Product Change Notification

Change Notification #: 113404 - 00
Change Title: Intel® Server System R1304GZ4GS9
PCN 113404-00
Product Design
Update the System Rear Panel,
BIOS/ME/BMC/FRUSDR Firmware, add
Mylar and a Plastic Block
Date of Publication: November 19, 2014

Figure One

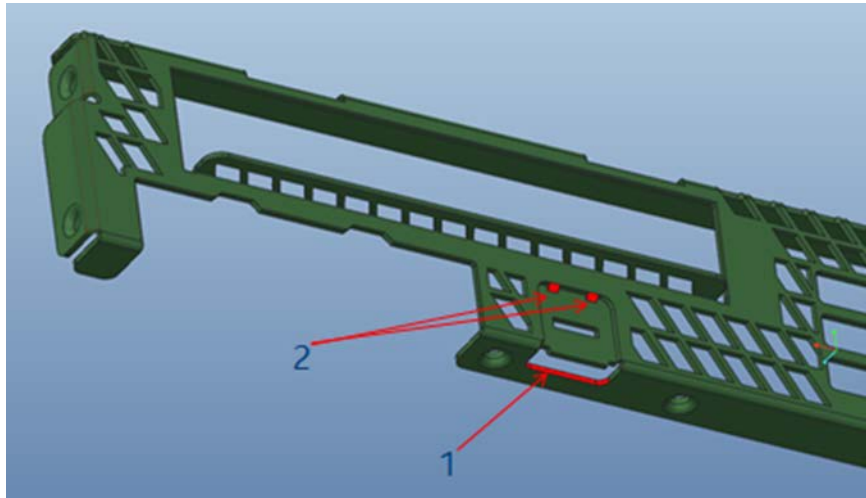
5. Add a connection at the bottom of the RMM4 (Remote Management Module 4) slot to improve structure strength. See Item 1 in the Figure One.
6. Update the one big center joint to two smaller joints so that the joints will not conflict with the LAN cable connector latch. See Item 2 in the Figure One.

Figure Two

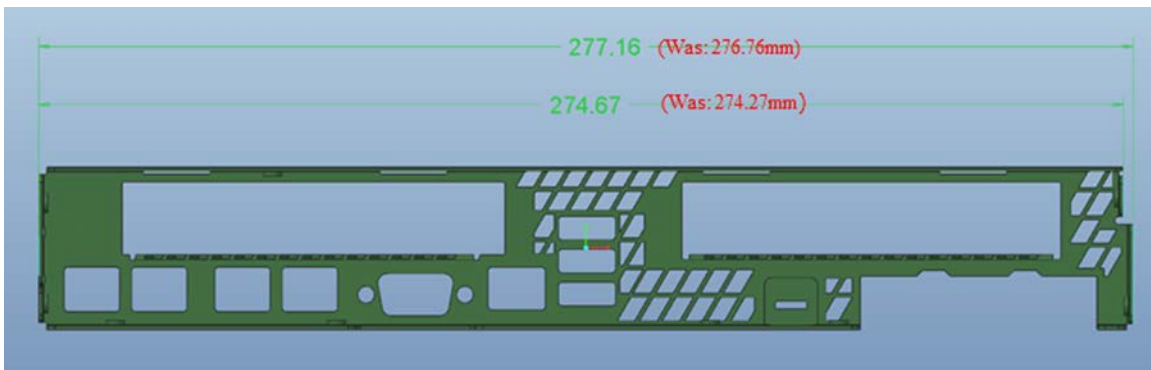
7. Enlarge by 0.2mm at both the left and right sides of the rear panel to improve the flexibility. The previous width was 276.76mm and 274.27mm. The updated width is 277.16mm and 274.67mm. See the Figure Two.

Figure Three

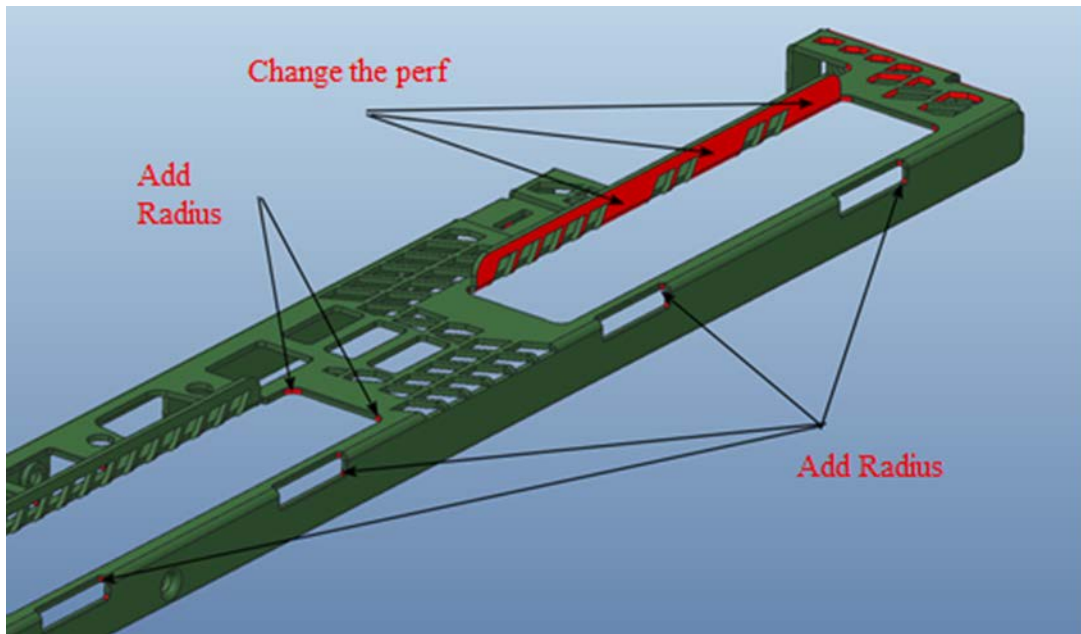
8. Update the perf and add radius to improve structure strength. See the Figure Three and Four.

Figure Five

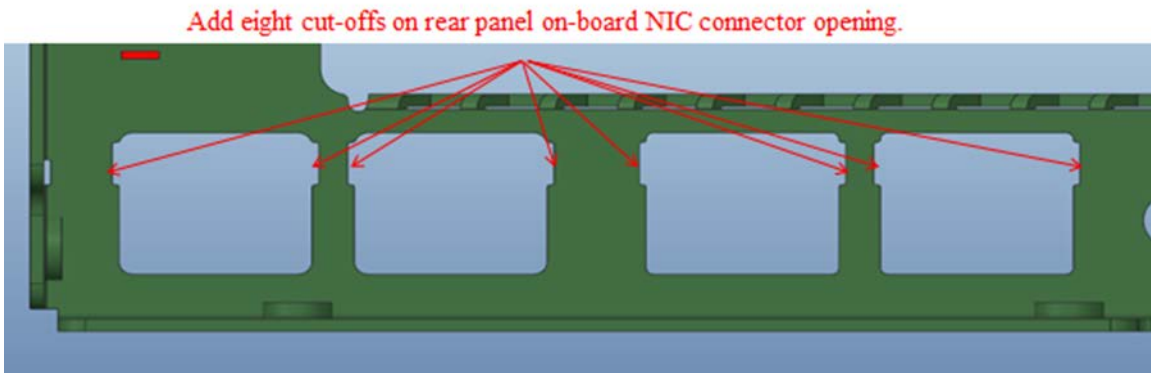
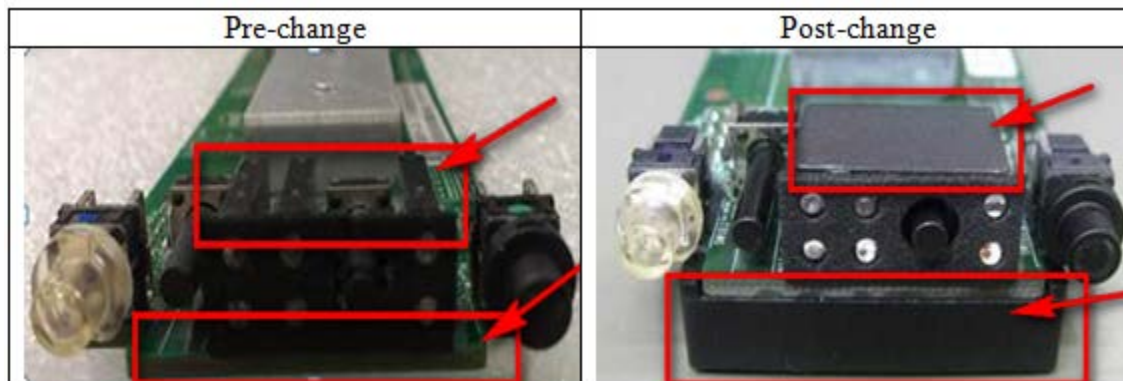
- Add eight cut-offs around the on-board NIC (Network Interface Controller) openings to improve the LED visibility. See the Figure Five.
